PLANNING NMA

Eton House | Explore
18-24 Paradise Rd, Richmond TW9 1SE

Rev 01

1 Consented vs Proposed Drawings

1.1 Consented - GF Plan

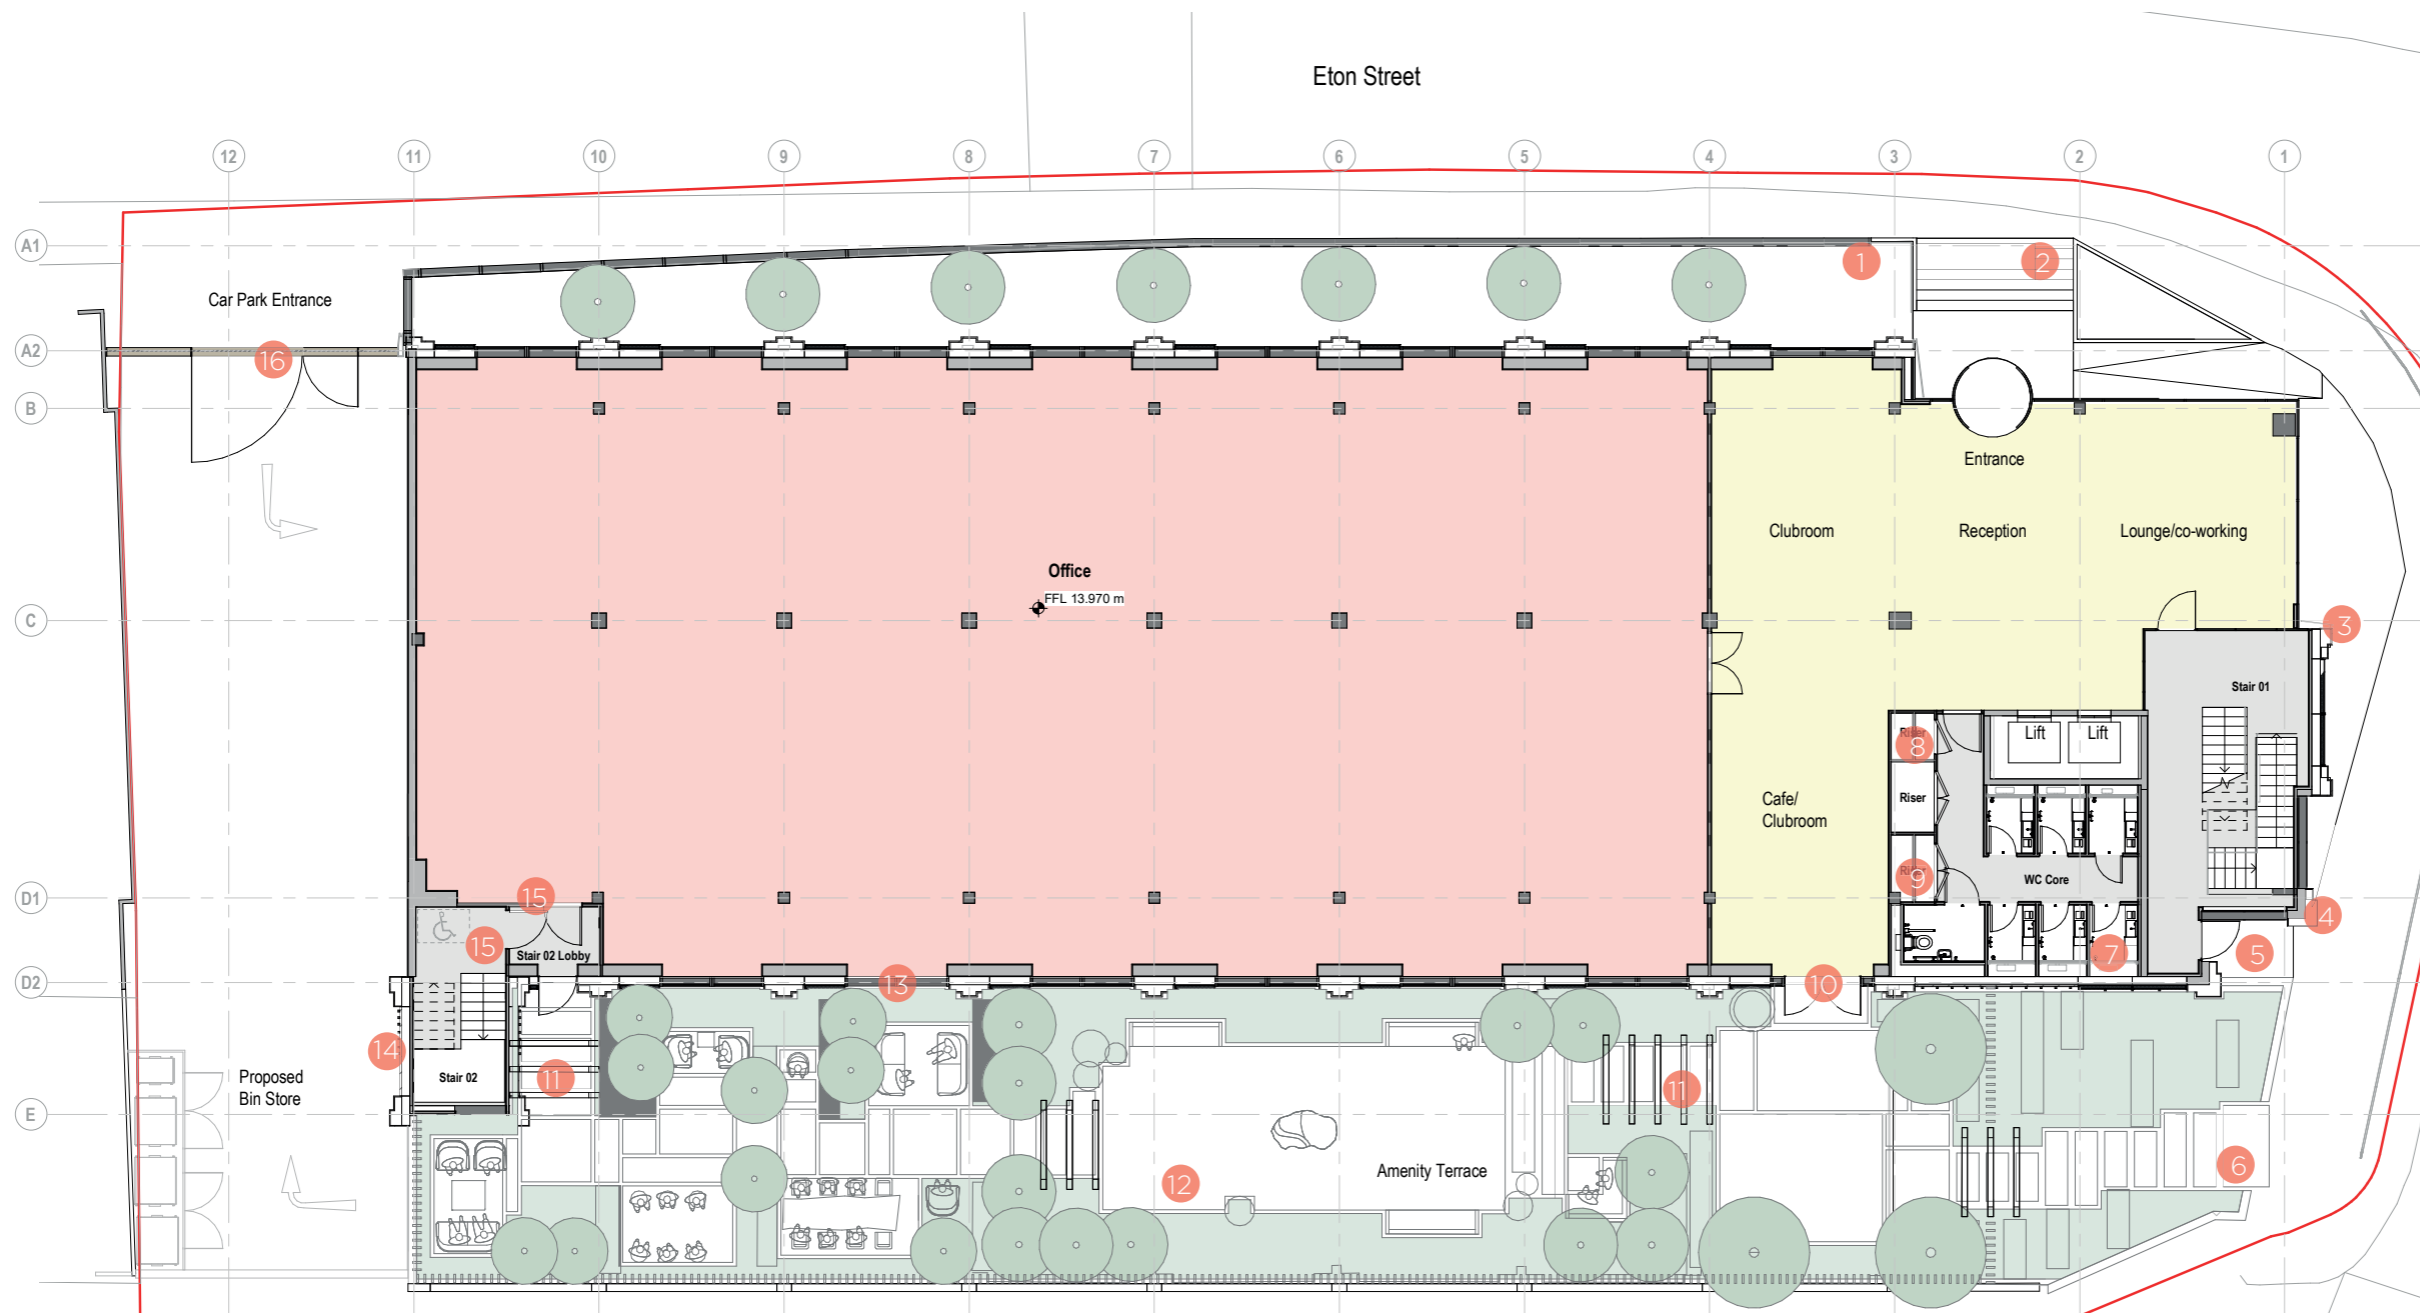
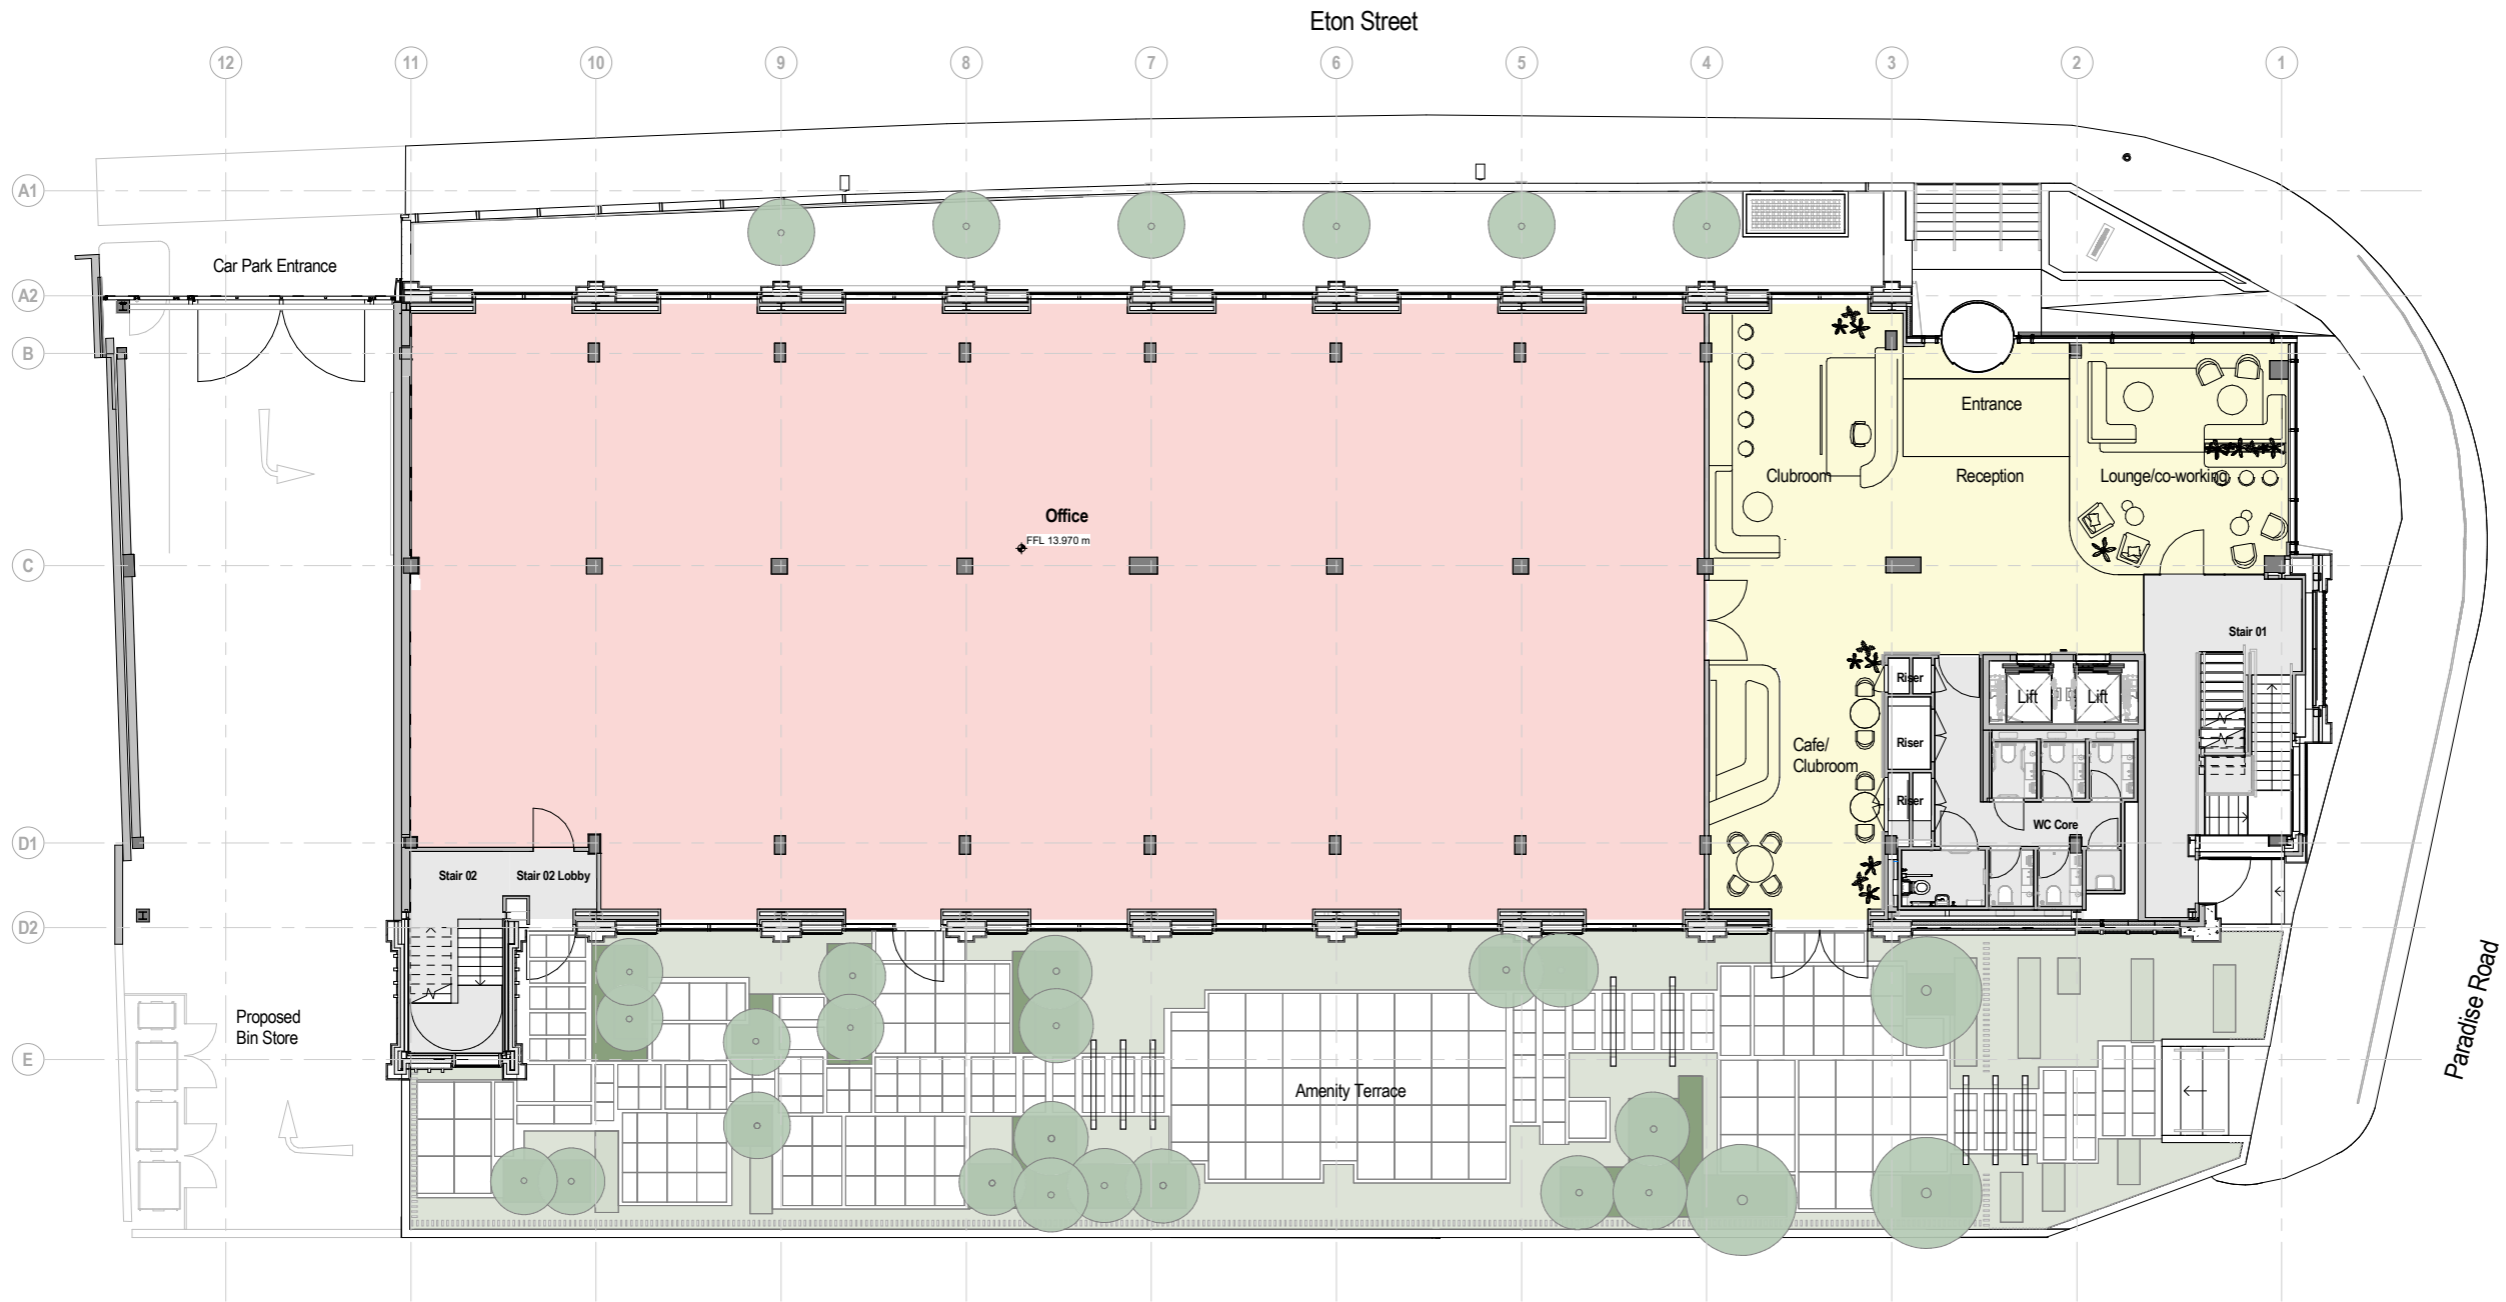
- 1 Smoke extract added here
- 2 Following more accurate street level survey Podium pushed across and stair width reduced to allow for compliant ramp.
- 3 Marginal adjustment to wall position to suit existing structure discovered during detailed survey
- 4 Corner pier adjusted to avoid cross past boundary line following detailed survey
- 5 2 no. additional steps added to work with existing levels
- 6 Steps now here from street level to garden level, required following detailed levels survey
- 7 This WC is now a cleaners cupboard with ventilation behind
- 8 Additional riser doors
- 9 Additional riser doors
- 10 Door widened to fill bay

- 11 Number of pergolas reduced
- 12 Floor finish broken up into smaller pavers
- 13 Additional means of escape added
- 14 Number of fins reduced due to buildability constraints.
- 15 Door removed to improve means of escape
- 16 Gate design revised
